WATER PERMIT NO. 8236-3

**RECOMMENDATION OF CHIEF ENGINEER FOR WATER PERMIT
APPLICATION NO. 8236-3, Arnie Beisch**

**REPORT TO THE CHIEF ENGINEER
ON
WATER PERMIT APPLICATION NO. 8236-3
ARNIE BEISCH
SEPTEMBER 14, 2016**

Figure 1- Map of approximate aquifer areal extent and proposed well locations along with nearby water rights/permits (Water Rights, 2017b) and Prairie Coteau aquifer observation well (Water Rights, 2017a)

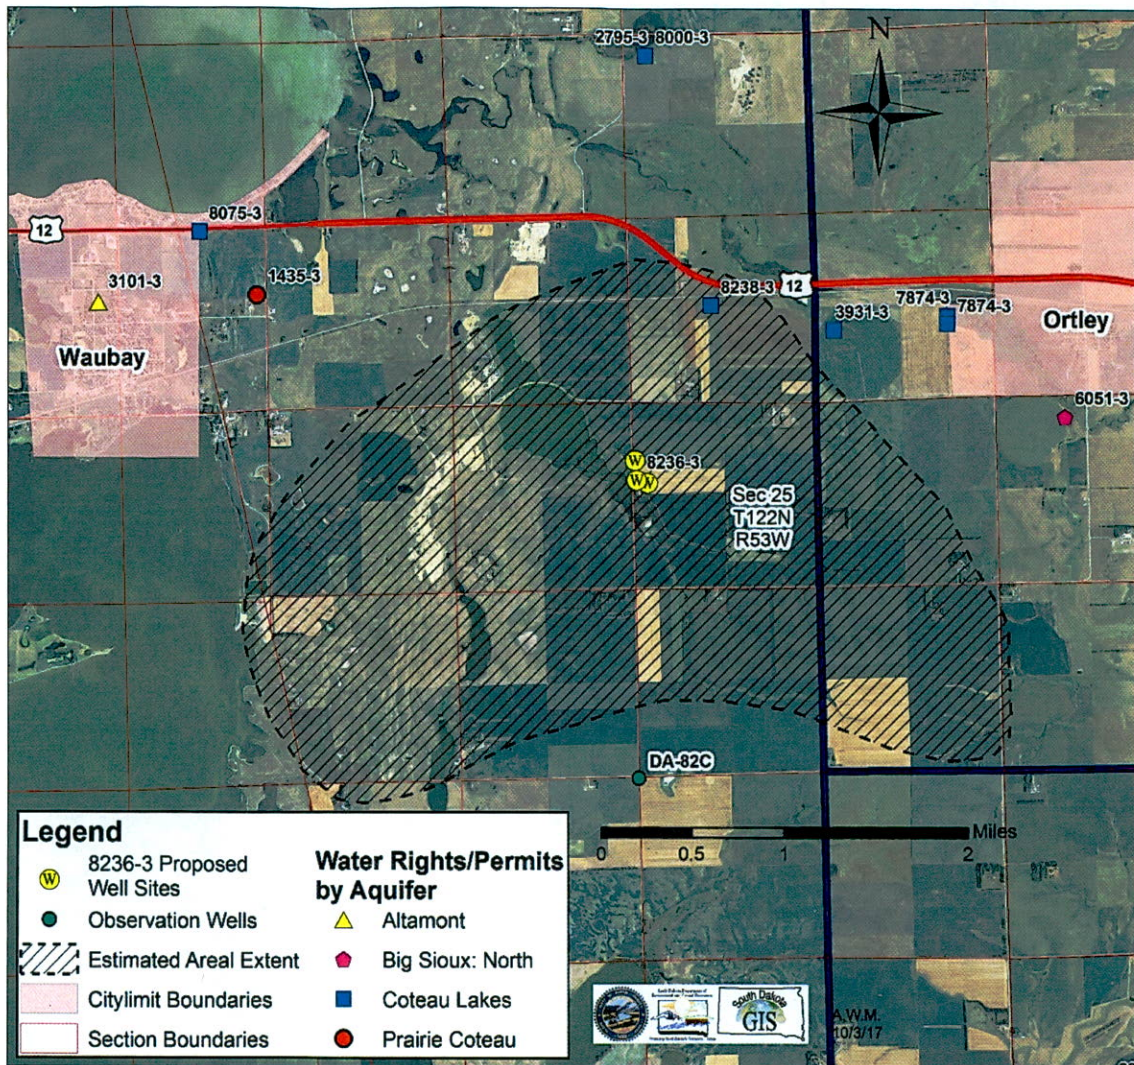
Based on the best available information including test hole and test well completion reports submitted by Mr. Beisch, and existing geologic and hydrologic reports by Hansen (1994; 1990), Leap (1988; 1972) and Thompson (2001), well completion reports on file with the DENR-Water Rights Program (Water Rights, 2017c), and lithologic logs on file with the DENR-Geological Survey (SDGS, 2017), the estimated minimum areal extent of the portion of the Prairie Coteau Mr. Beisch proposes to withdraw water from is approximately 5,200 acres. This portion of the Prairie Coteau aquifer may be larger than the estimated minimum extent. This portion of the Prairie Coteau aquifer may also be in hydraulic connection with the Coteau Lakes aquifer underlying and surrounding Blue Dog and Bitter Lakes (SDGS, 2017; Water Rights, 2017a, 2017b, and 2017c). Hedges and others (1982) estimated the combined areal extent of the Prairie Coteau aquifers in Day County to be 500,000 acres with more than an estimated 675,000 ac-ft of recoverable water in storage. Due to the discontinuous nature of the Prairie Coteau aquifer deposits not all of that water is available at any one well. The test well completion reports for this irrigation project indicate this portion of the Prairie Coteau aquifer is under confined conditions. Figure 1 shows a map of the estimated minimum areal extent of the portion of the Prairie Coteau aquifer Mr. Beisch proposes to use. Table 1 lists the water rights/permits shown in Figure 1.

Figure 2- Hydrograph for DENR-Water Rights Program observation well DA-82C located approximately 1.5 miles south of the proposed well sites (Water Rights, 2017a)

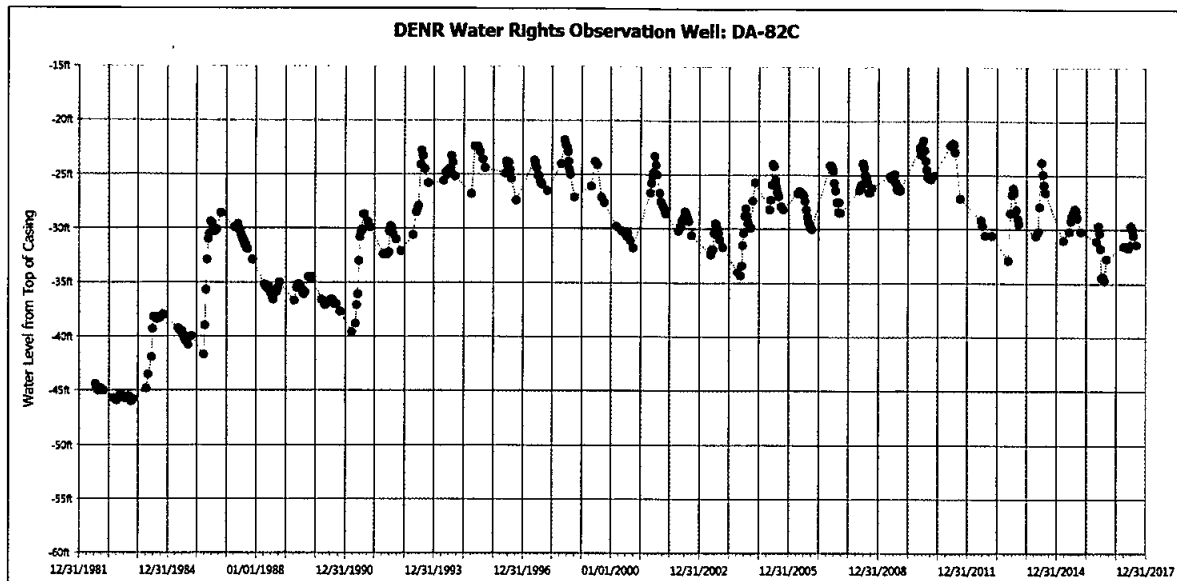
There does not appear to be any development by appropriative users for the portion of the Prairie Coteau aquifer that DA-82C is completed into. Thus, it is representative of relatively static conditions within that particular portion of the Prairie Coteau aquifer. The observation well is under confined conditions. The hydrograph shows there is more water in storage now than in the past and the water level recovers each spring. Climatic conditions dominate the overall changes in water level of the observation well. This means the portion of the Prairie Coteau aquifer DA-82C is completed into is not being stressed by any domestic use pumping. Thus, the water level rise shown on the hydrograph for each spring shows there is recharge to the portion of the Prairie Coteau aquifer DA-82C is completed into. The recharge of that portion of the Prairie Coteau

means it is likely the portion of the Prairie Coteau aquifer Mr. Beisch proposes to use also receives recharge.

Figure 3- Domestic wells on file with the DENR-Water Rights Program that appear to be completed into the portion of the Prairie Coteau aquifer this application proposes to use (Water Rights, 2017c)

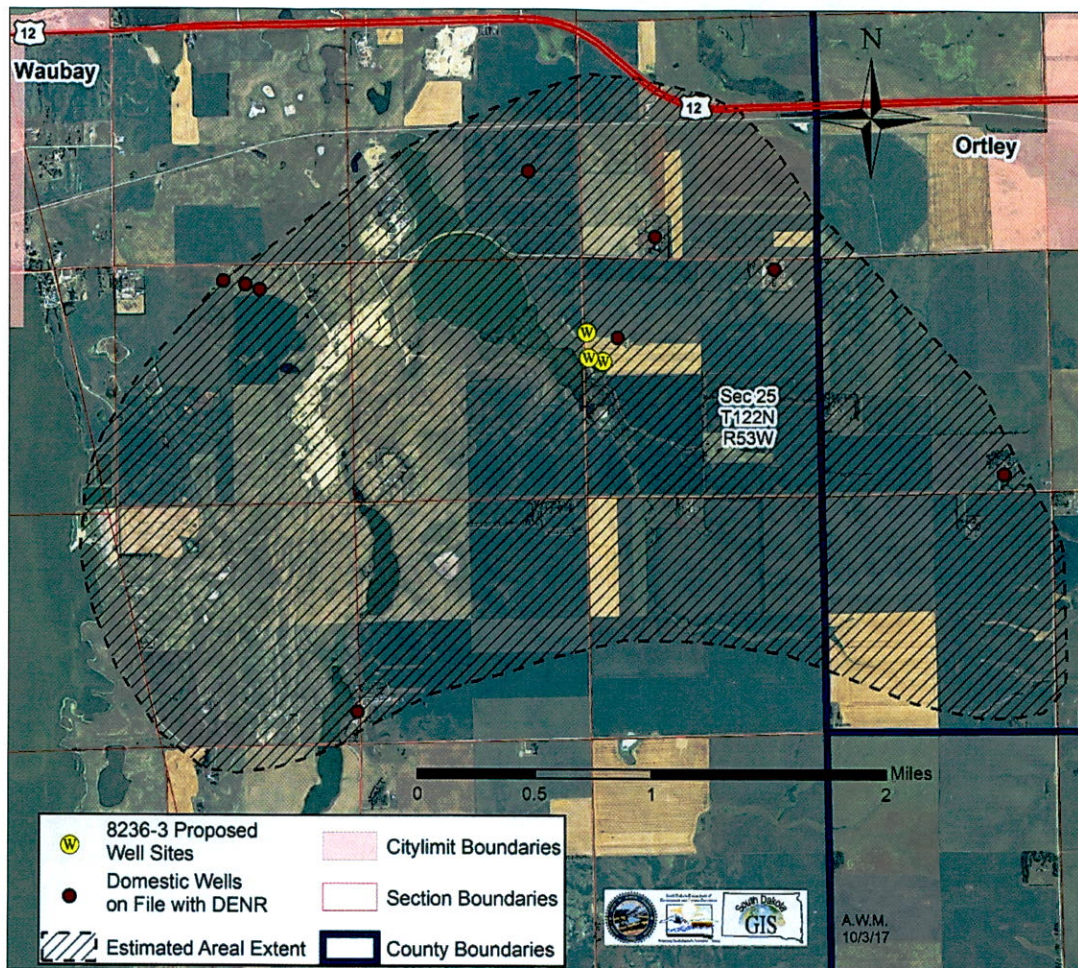
The domestic well nearest to the proposed wells is at the farmsite of Mr. Beisch's son, approximately 0.1 miles away, based on a map provided by Mr. Beisch. The other domestic wells on file with the DENR-Water Rights Program are approximately 0.5 or more miles away. There is no history of well interference issues within approximately 20 miles of the proposed well sites. At the proposed well sites and domestic wells located within approximately one mile, there is between 40 and 80 feet of artesian head pressure above the top of the aquifer (Water Rights, 2017a and 2017b).
